OWTS

SEWAGE SYSTEM REVIEW

SANTA CLARA COUNTY
DEPARTMENT OF ENVIRONMENTAL HEALTH
Project Description SR No. SR0868945

ADDITION
2149 GREEN ACRES LANE
MORGAN HILL, CA 95037
APN : 776 – 29 – 029

SITE PLAN

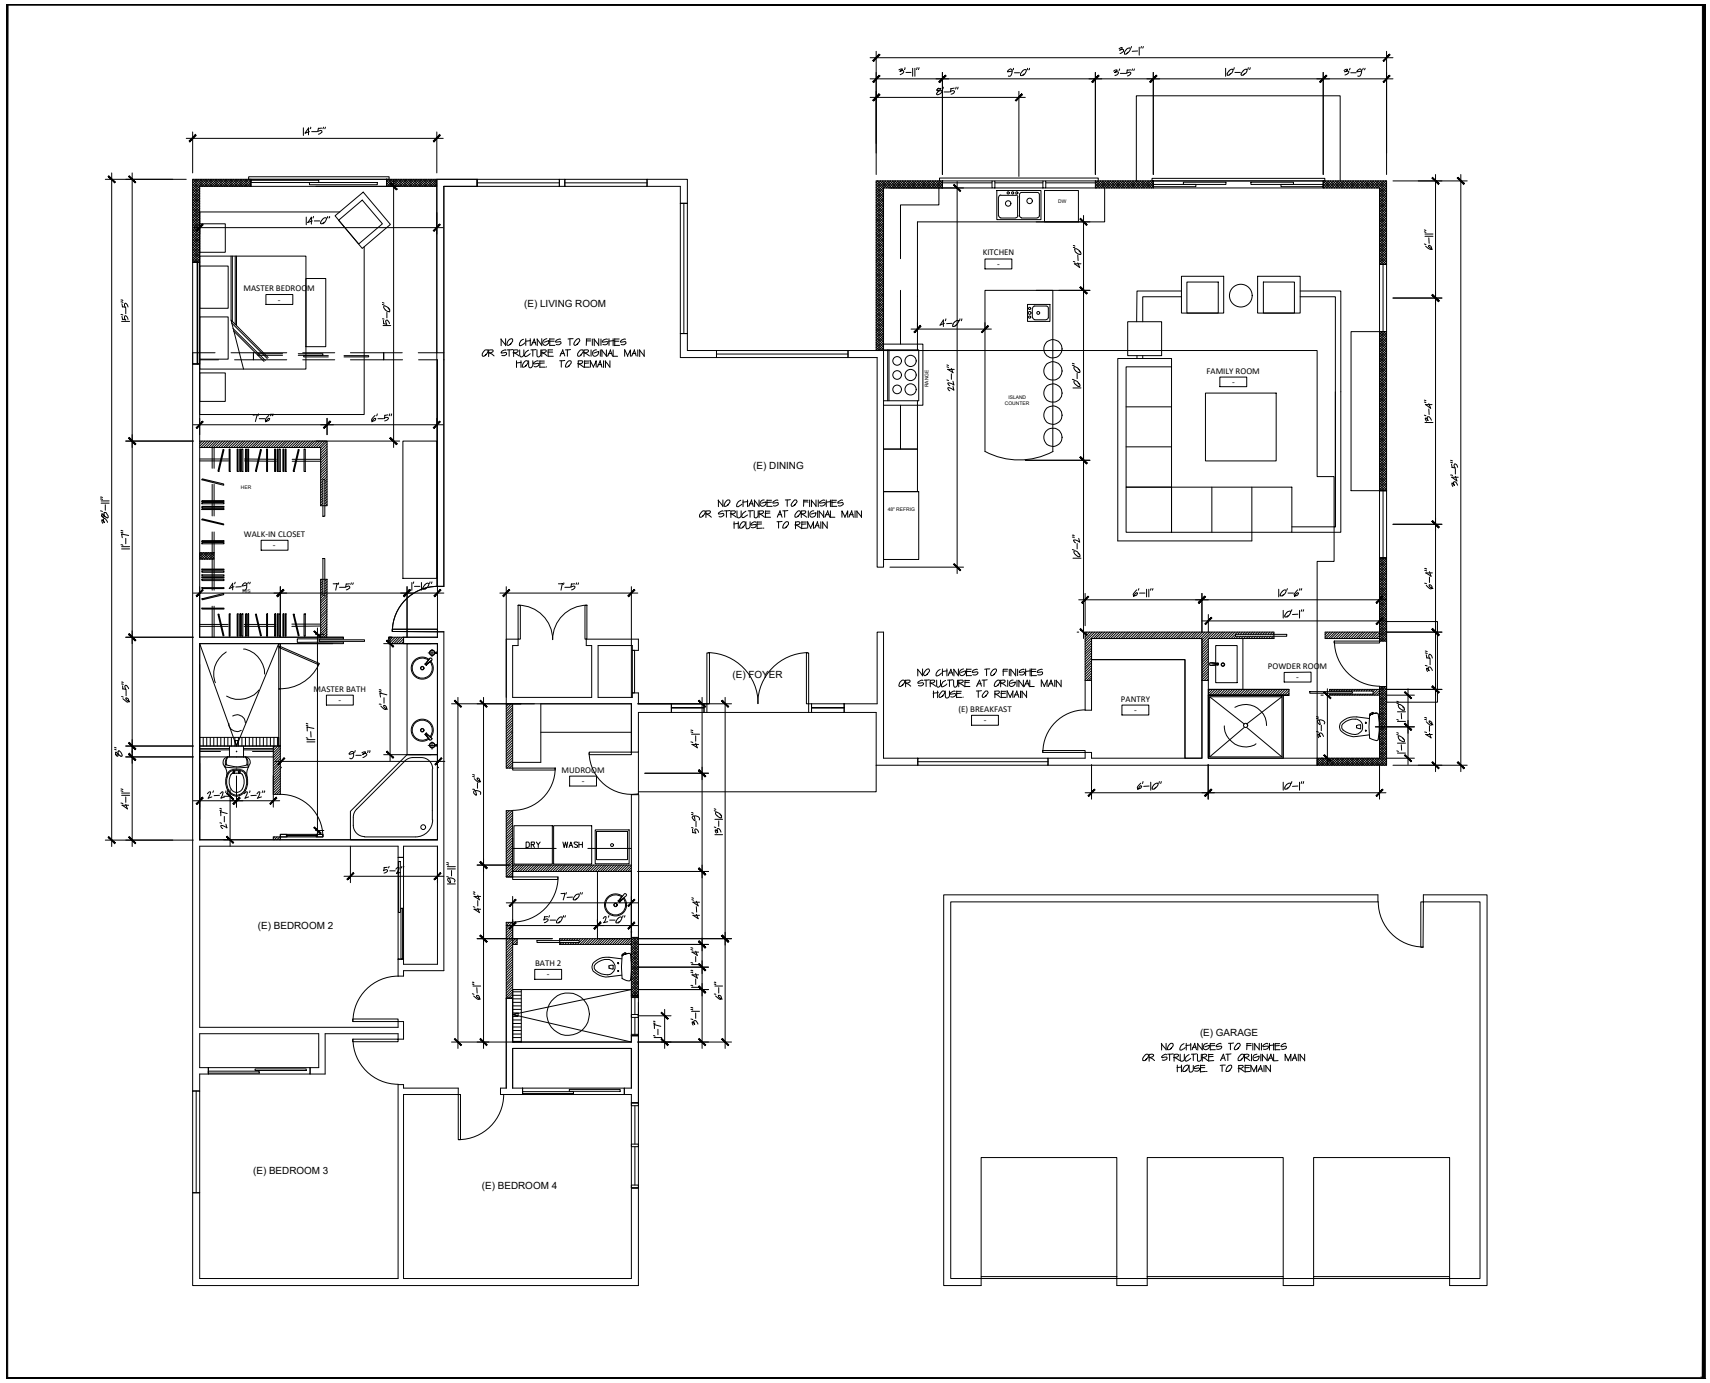
APPROVAL RECOMMENDED

X With existing System (Existing No. 26949)
X Install/modify system per plan (describe below)
[Obtain a permit from Environmental Health]

Abandon (e) 1200gal tank. Abandon (e) leachfield withibn 10 feet of new strucutre and driveway. Install new 1500gal tank w/D-vavle and leachfilled to mainatin a minimum 131'+131' leach field
